### **ADDENDUM # 6 Bid 20C6, Waverley Elementary School - New Construction**

## **ADDENDUM NO. 6**

RE: **WAVERLEY ELEMENTARY SCHOOL REPLACEMENT**

| Sheet         | S4.7                  | OF             |

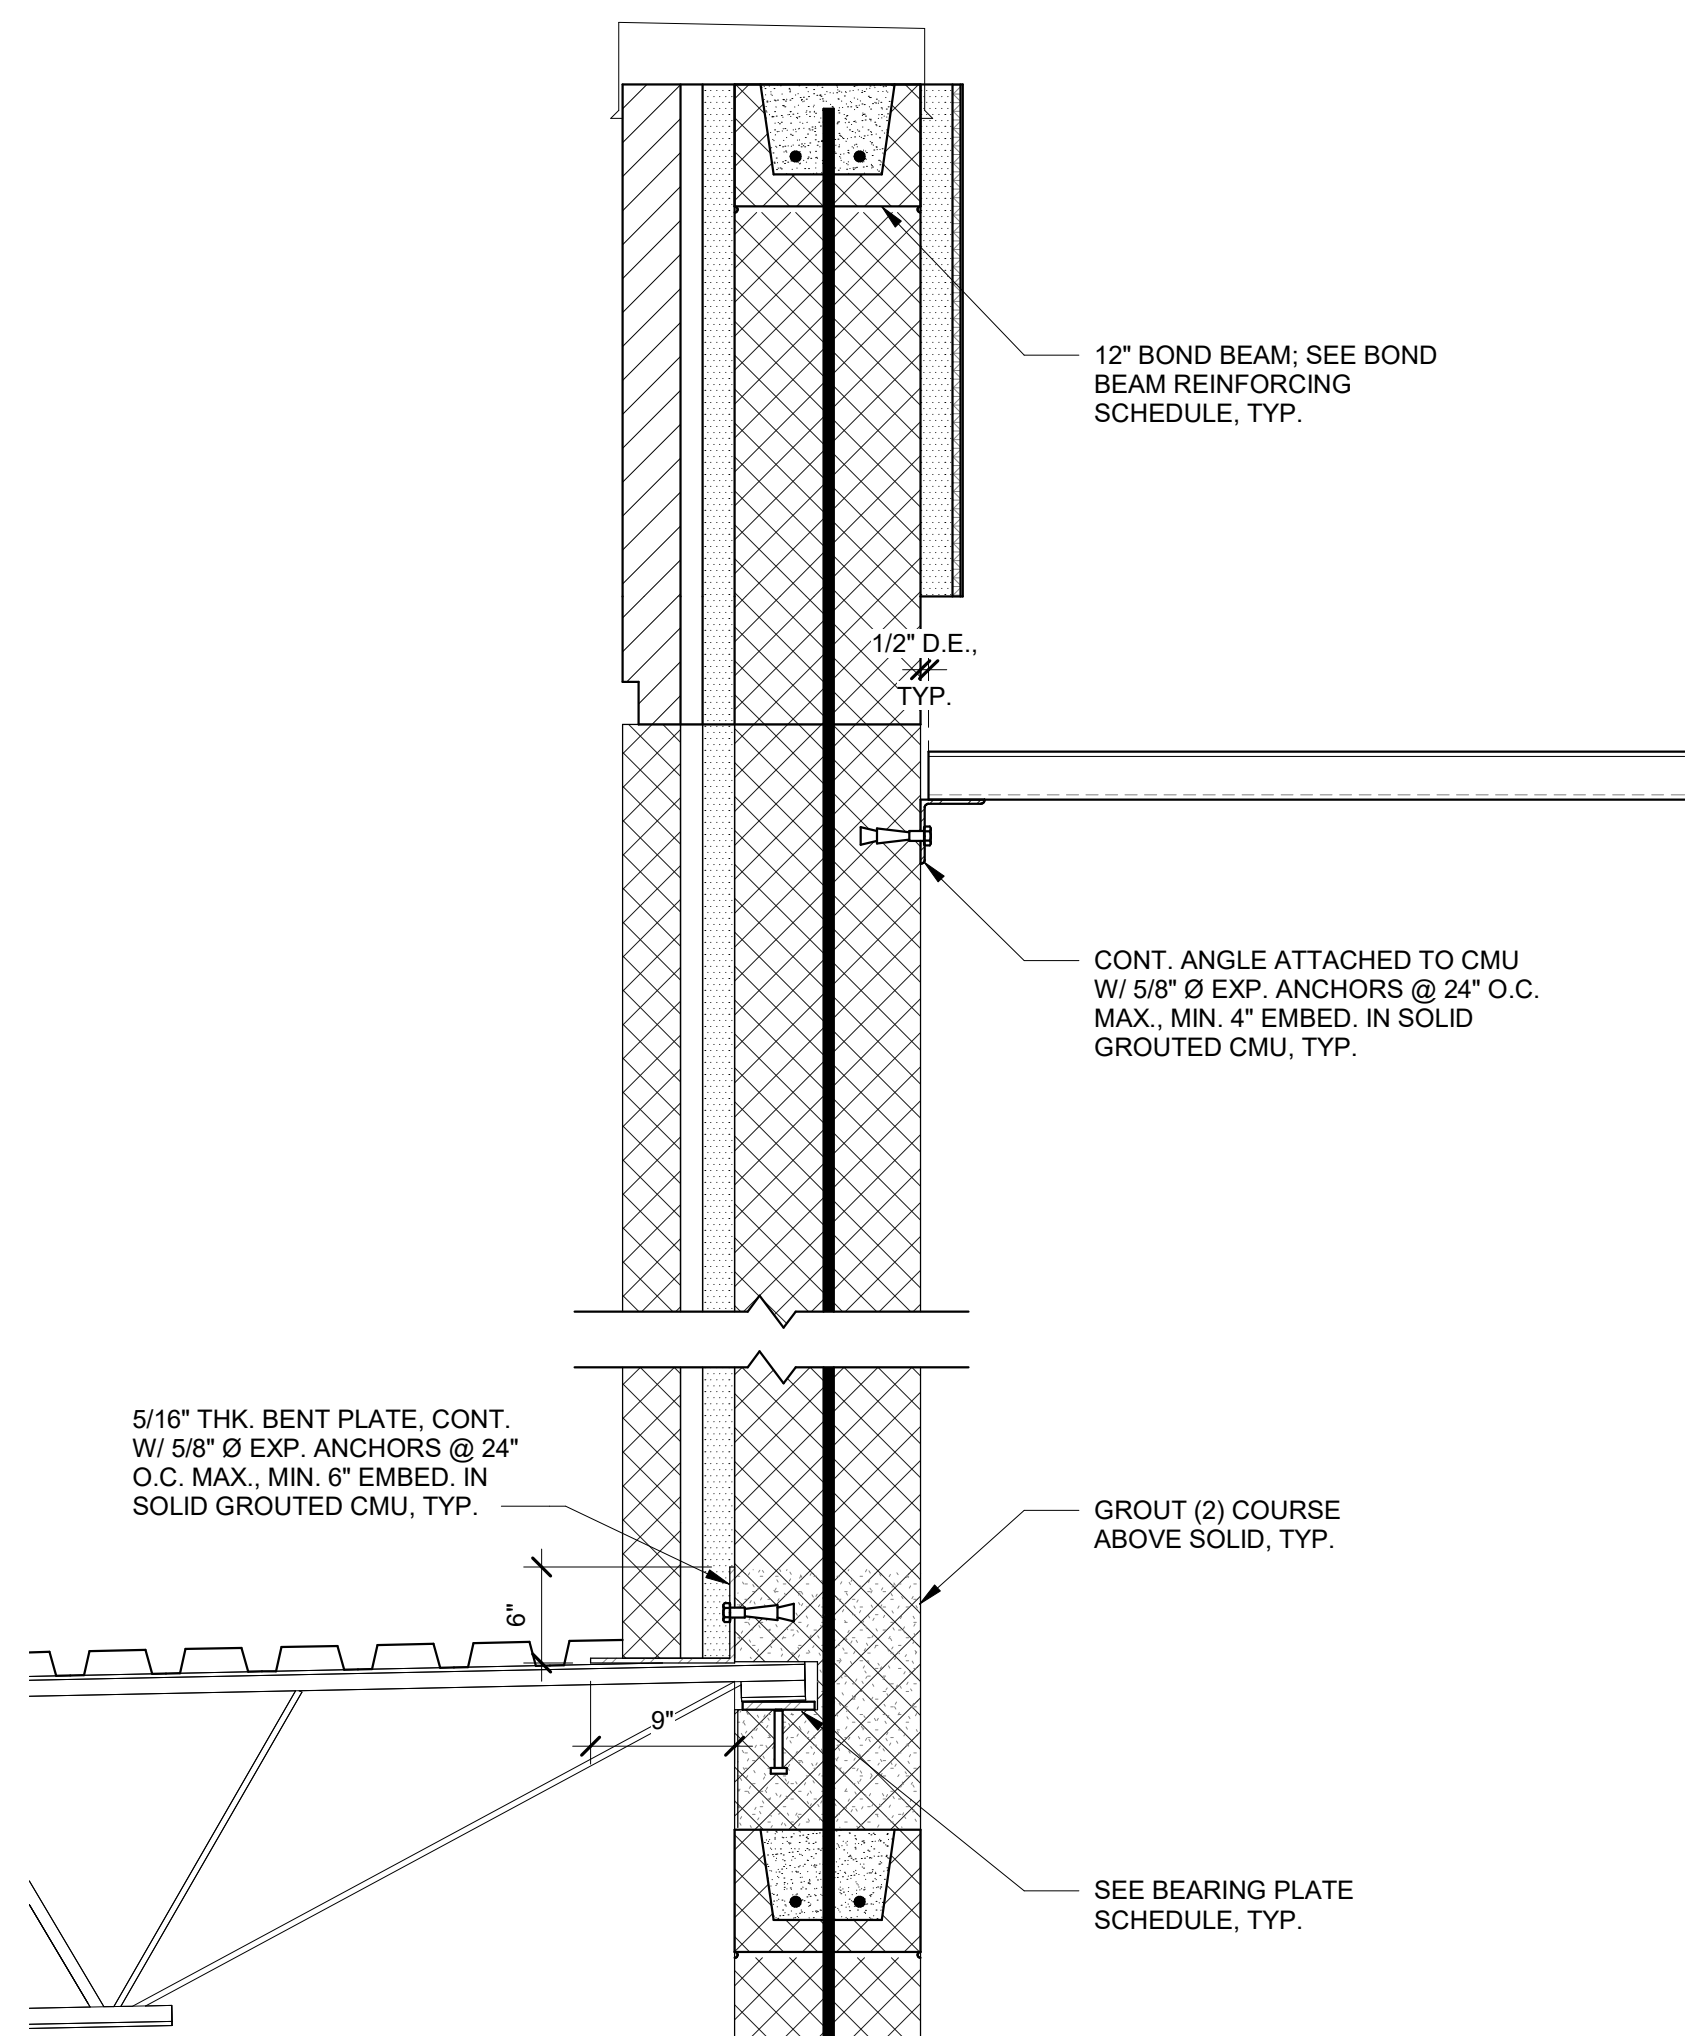
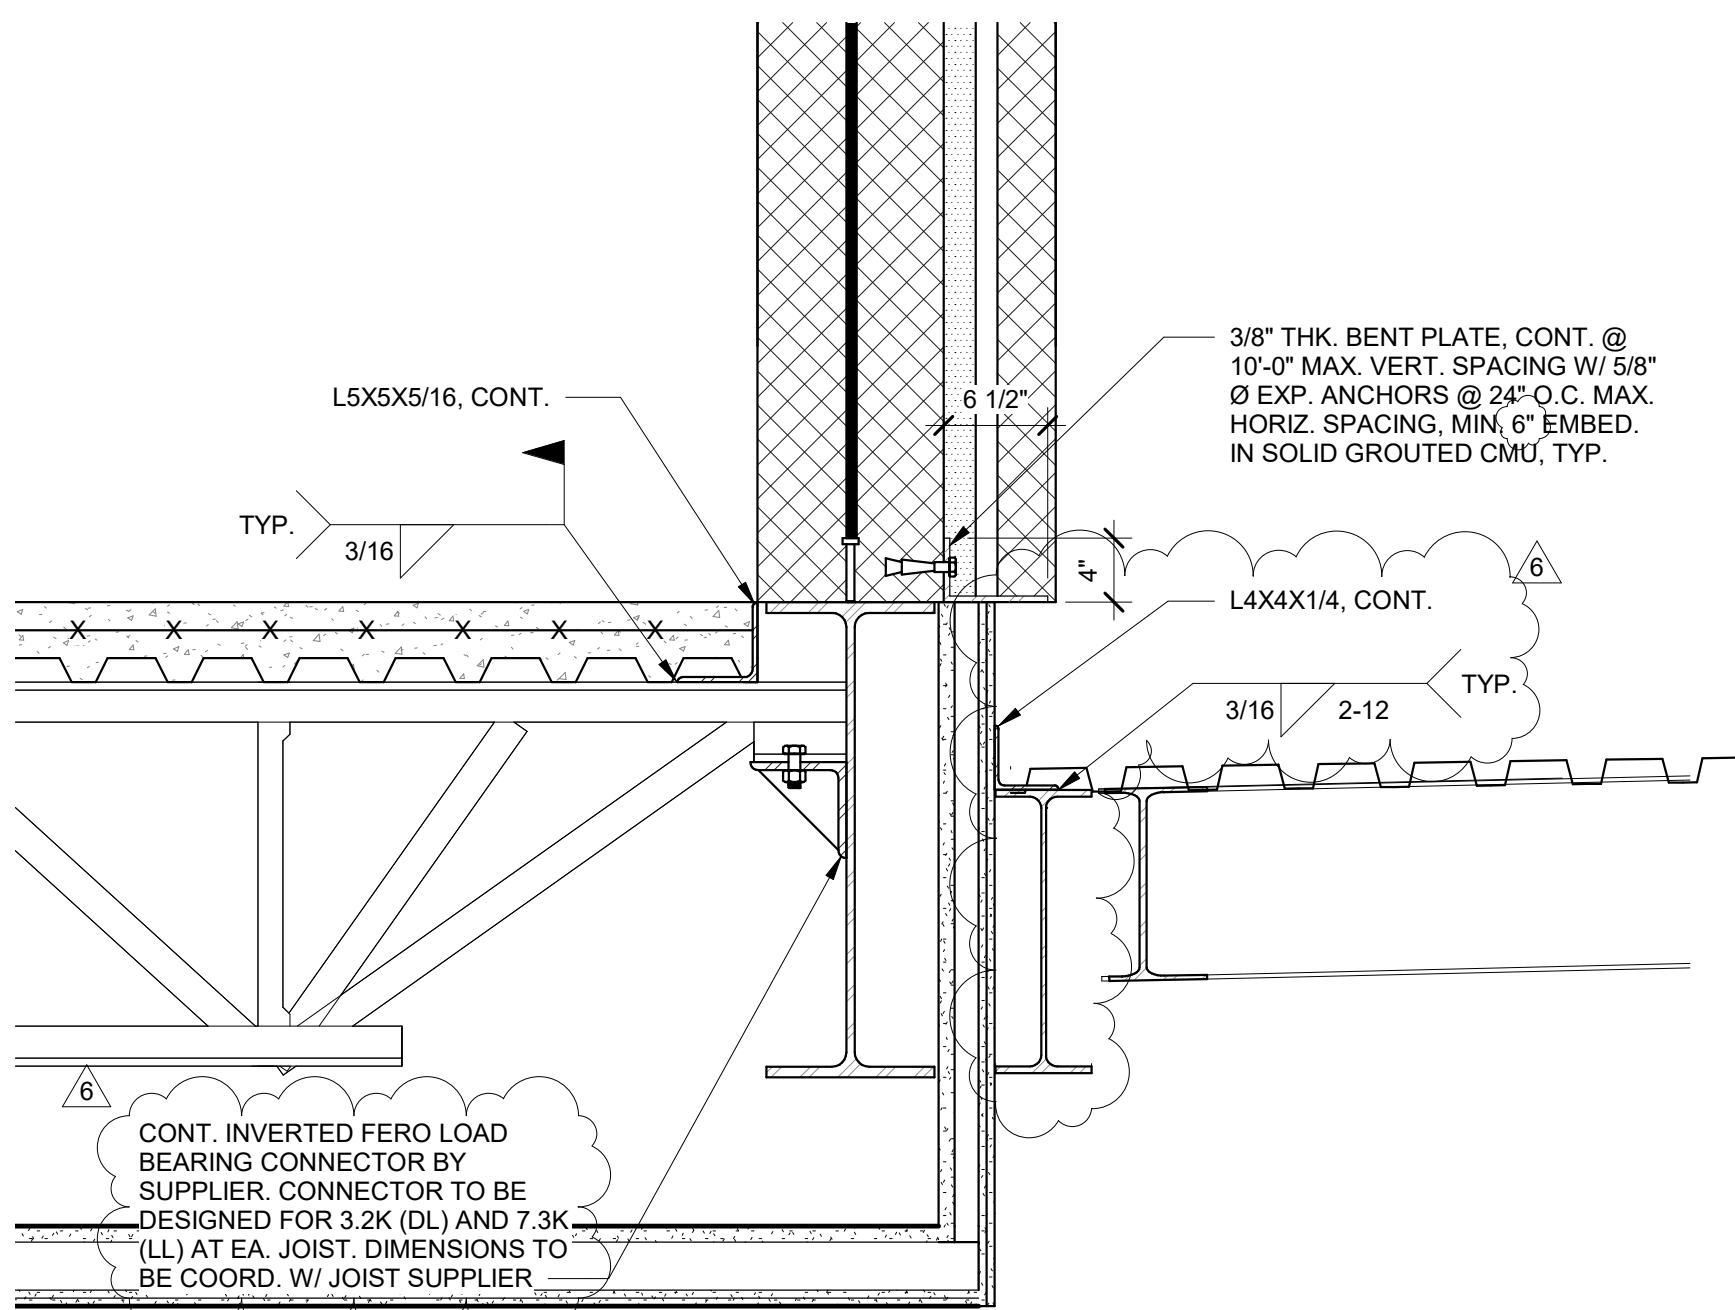
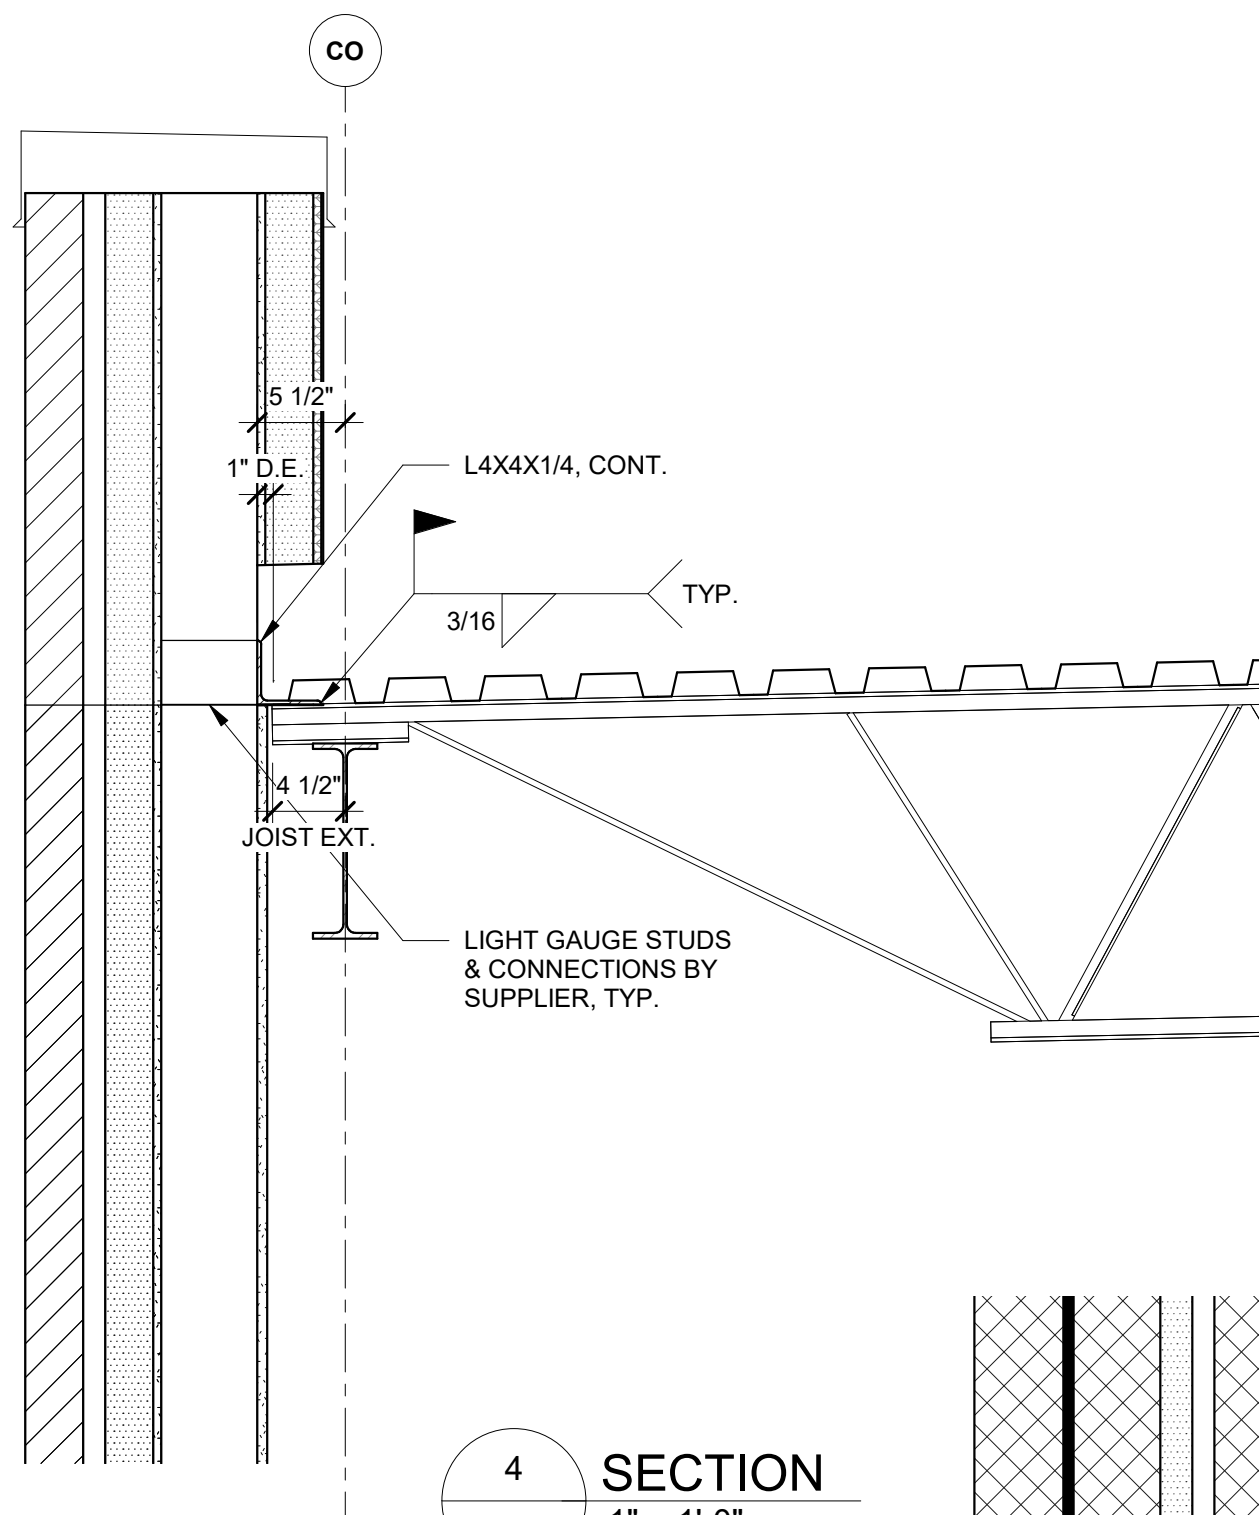
- **REVISE** WT size to “WT12.5X27.5” in detail 2/S4.6.
13. **DELETE** Drawing Sheet S4.7 – ROOF FRAMING SECTIONS; Issued for Bid, dated 03/06/2020; **ADD** Drawing Sheet S4.7 – ROOF FRAMING SECTIONS; ADDENDUM #6, (Revision dated 04/22/2020).

- **REVISED** details as indicated.
14. **DELETE** Drawing Sheet S5.1 – JOIST LOAD DIAGRAMS; Issued for Bid, dated 03/06/2020; **ADD** Drawing Sheet S5.1 – JOIST LOAD DIAGRAMS; ADDENDUM #6, (Revision dated 04/22/2020).
